Our Ref: 20-12/001182
CRC Ref: mcuc 2021_4490/1
Date: 18 March 2022

RE: RESPONSE TO INFORMATION REQUEST IN RELATION TO AN APPLICATION FOR MATERIAL CHANGE OF USE FOR 'MULTIPLE DWELLINGS' AND 'SHORT-TERM ACCOMMODATION' OVER LAND AT 69 – 73 MURPHY STREET, PORT DOUGLAS

We hereby provide the following information in response to Council's Information Request dated 22 December 2021.

DA50.002

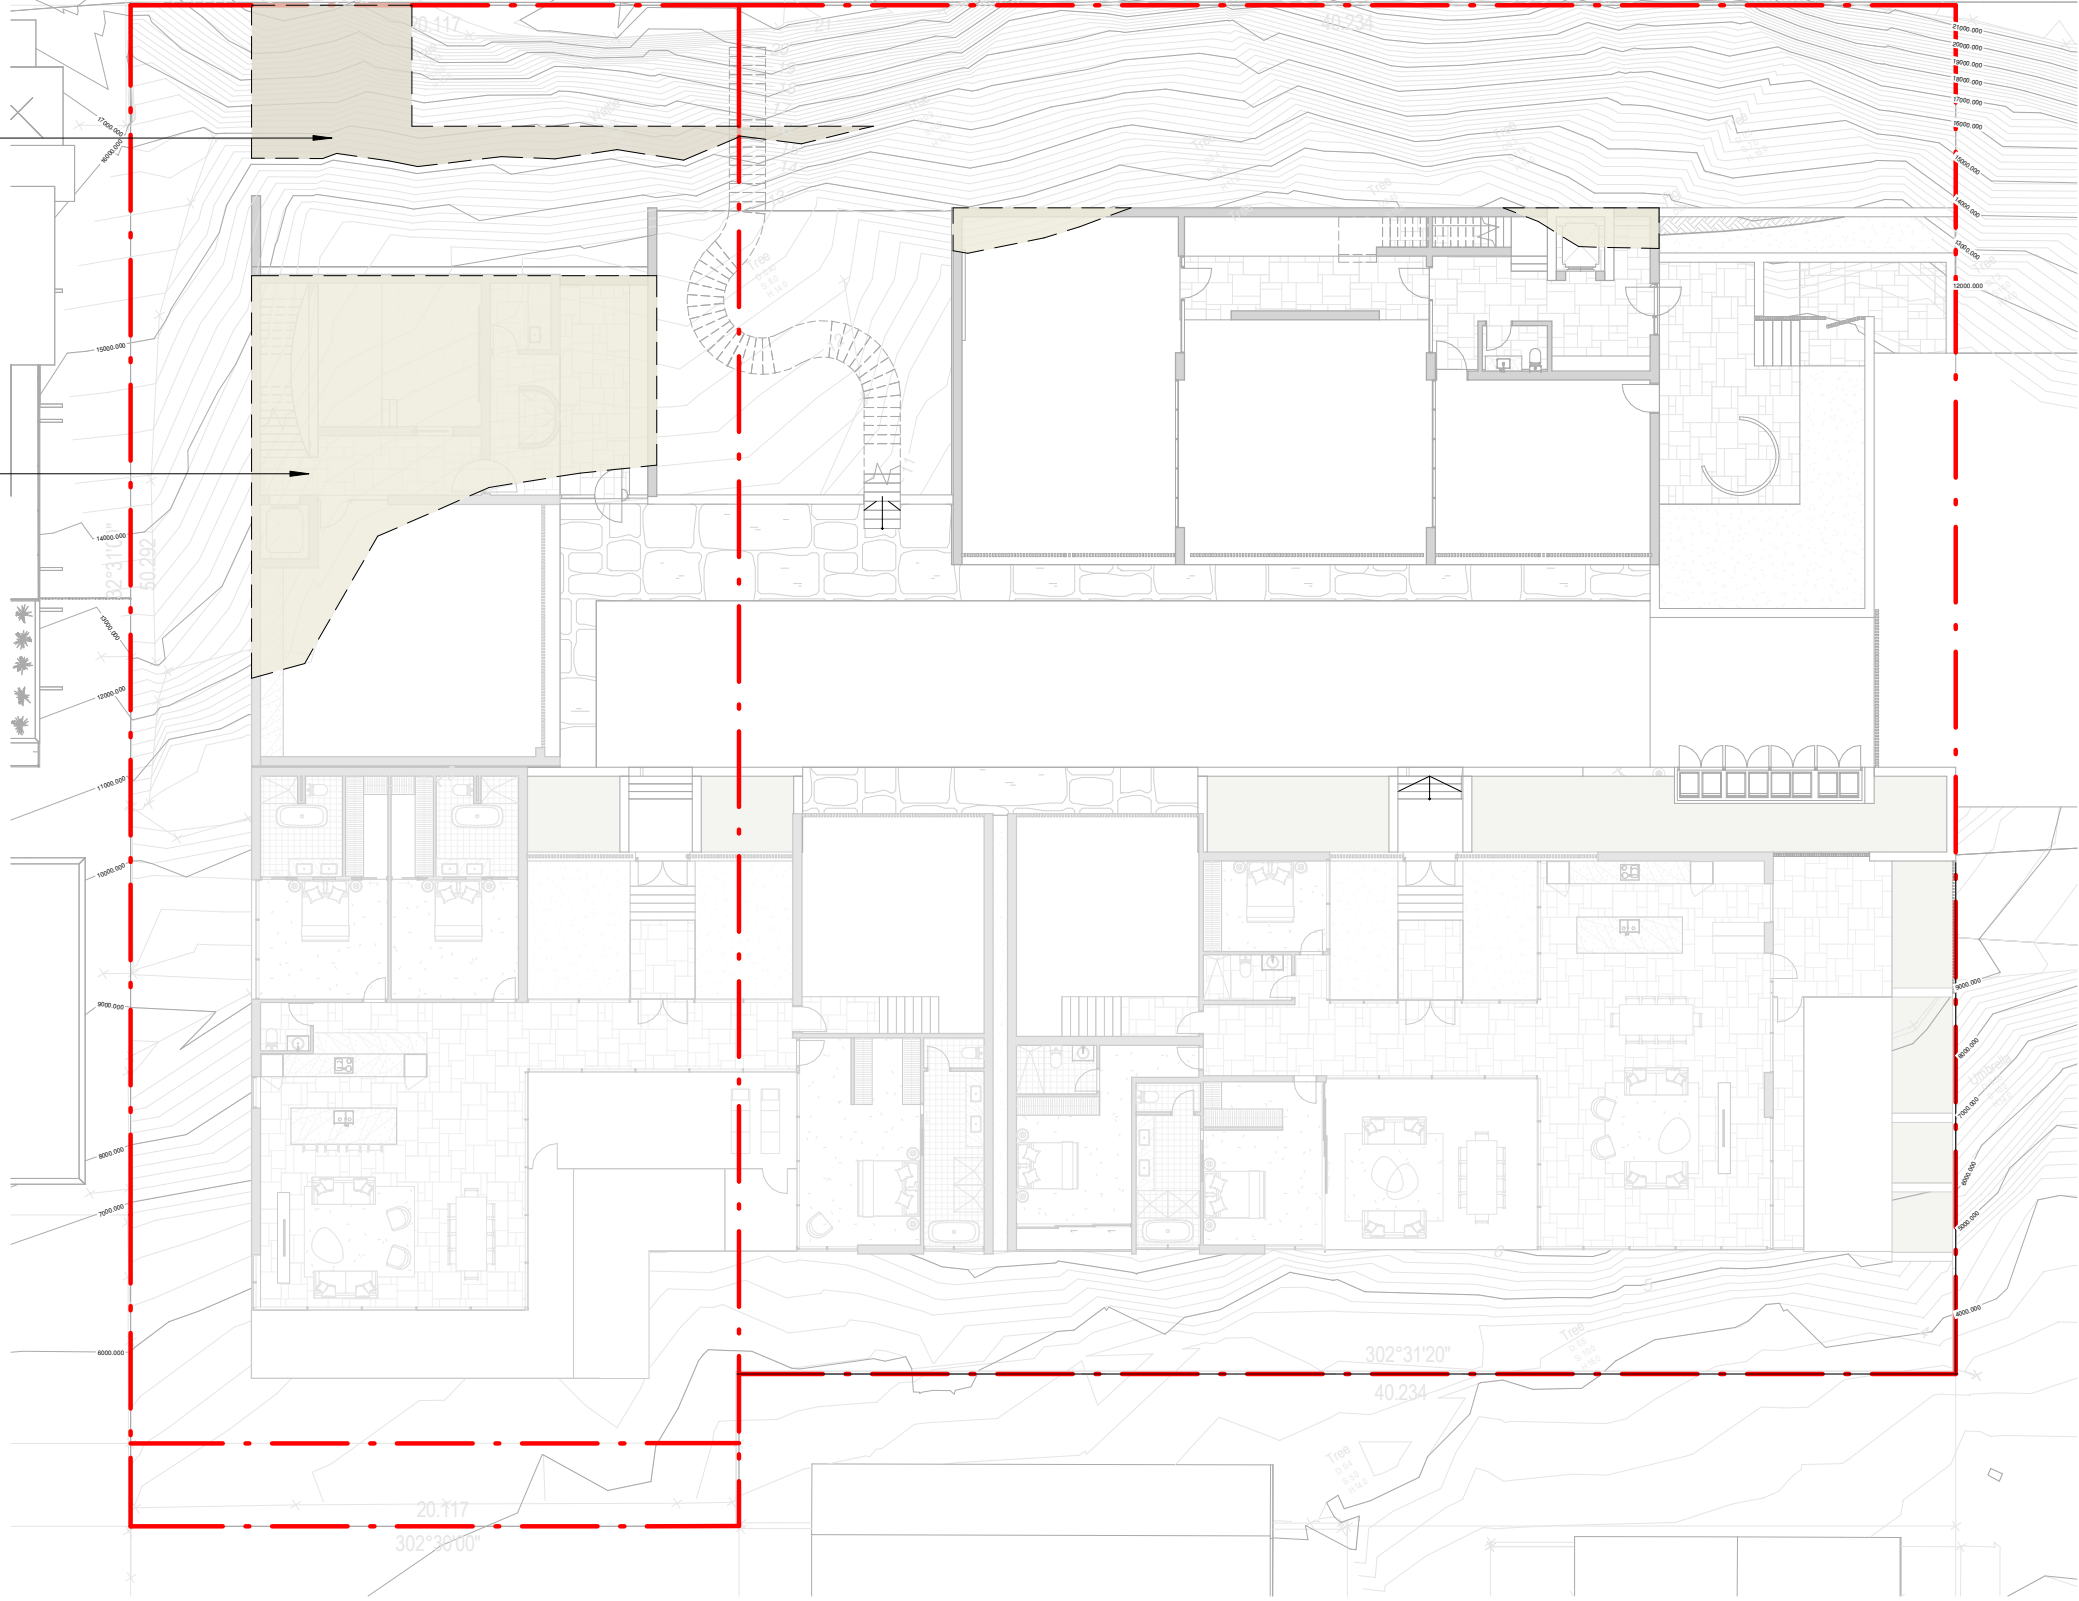
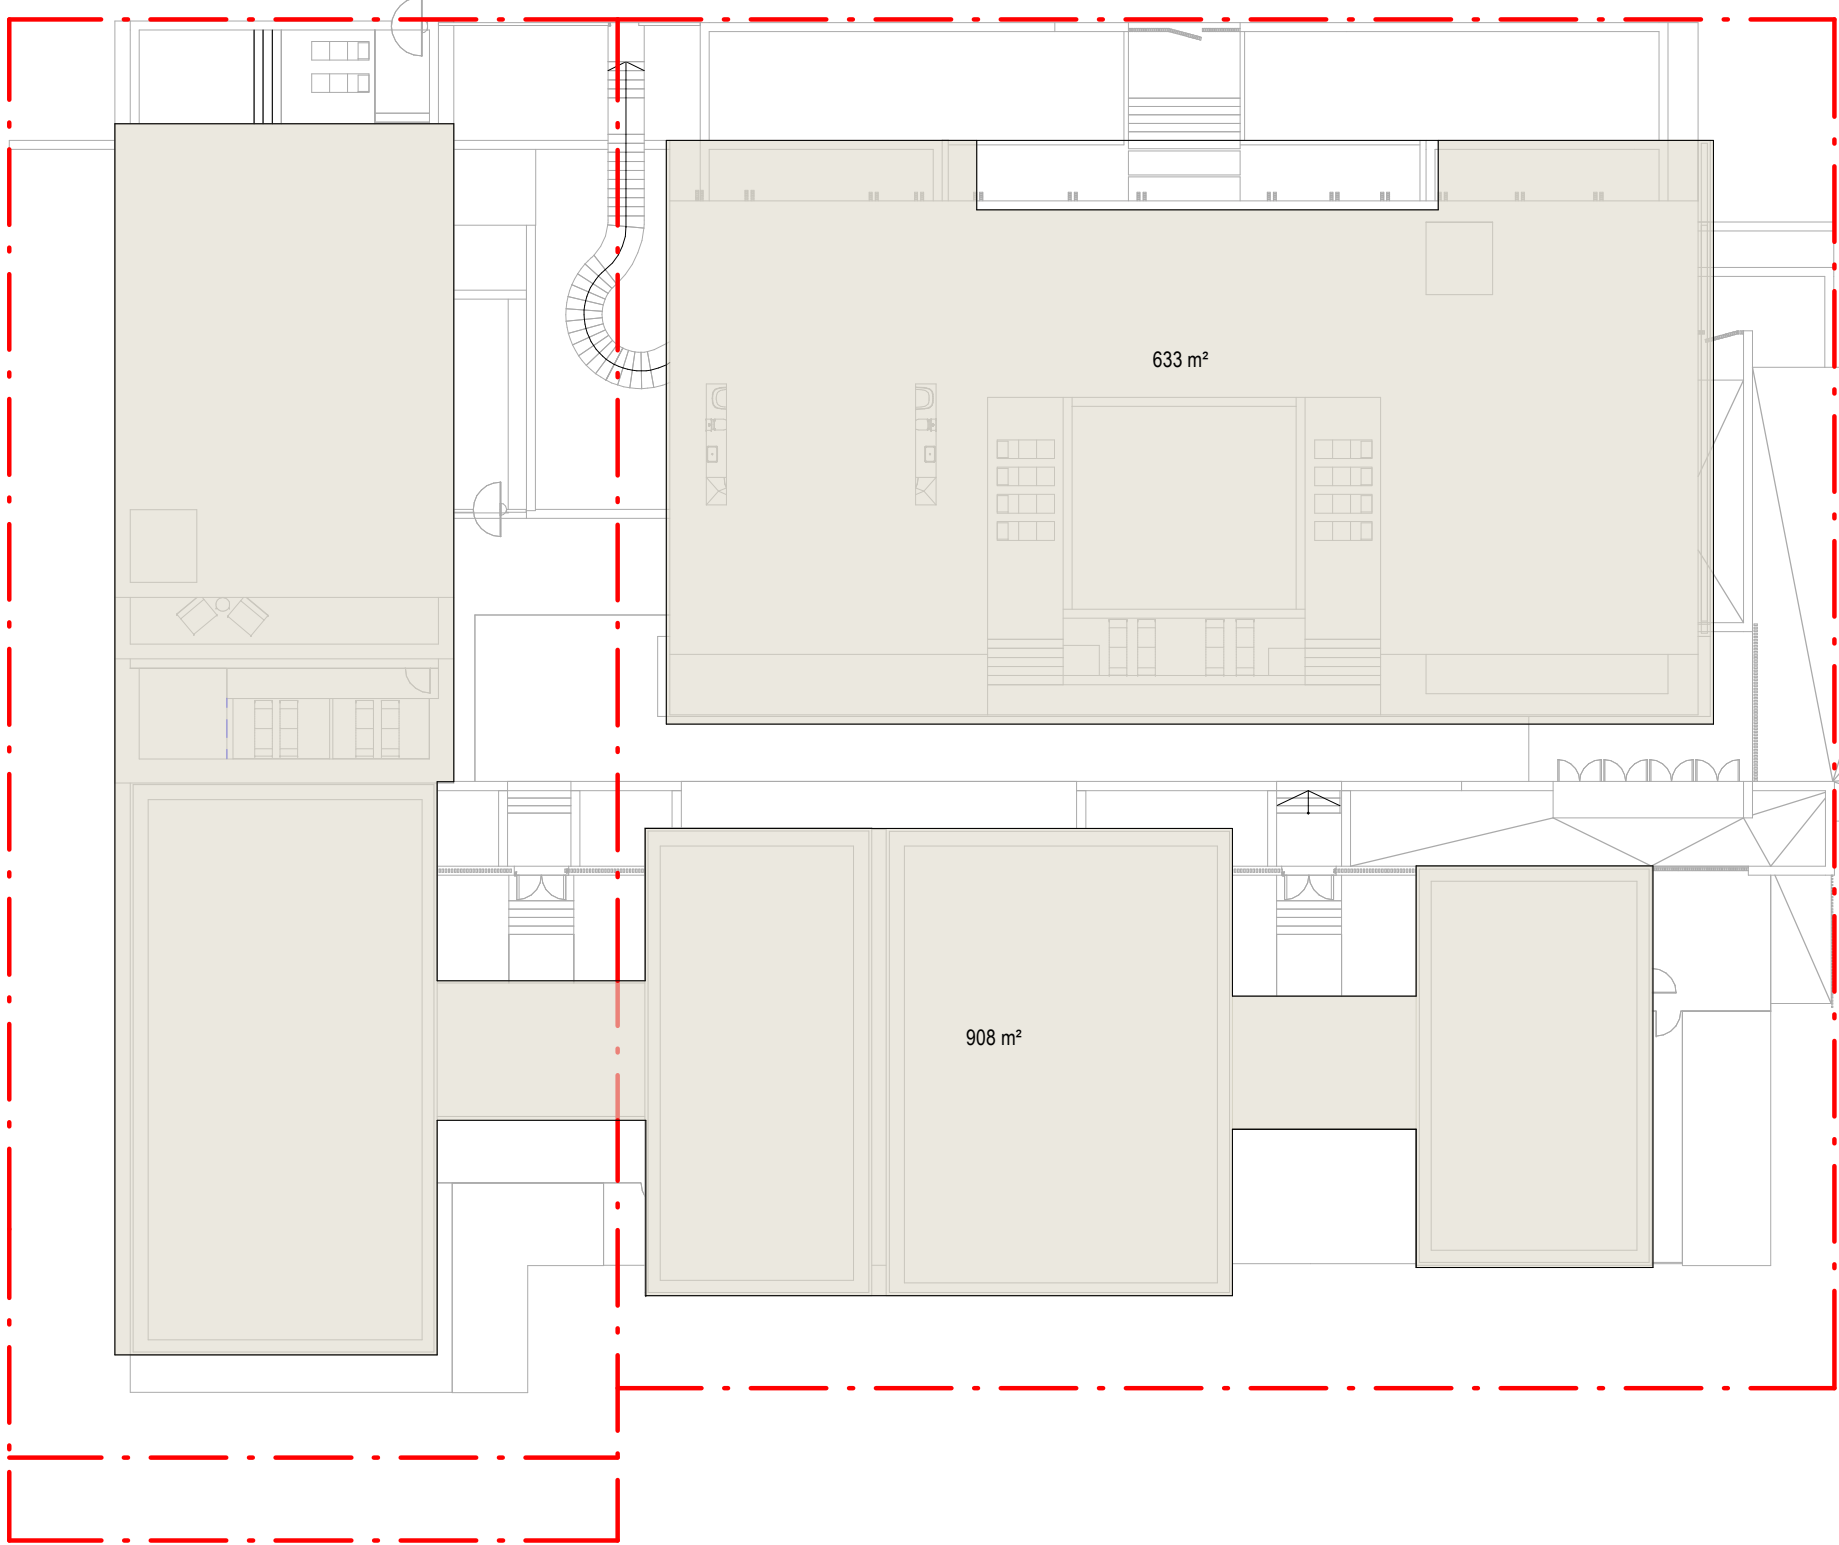
8. The applicant is requested to clarify the proposed volume to be filled/removed and to confirm the expected truck movements to achieve required earthworks. The confirmation should include the existing surface contours overlaid with design site levels.

Proposed excavation areas are shown on DA50.002 within **Annexure 1** and are relatively minor. Fill figures are not available at this stage. In any case, this is considered to be a construction management issue which would be regulated by a future Operational Works approval.
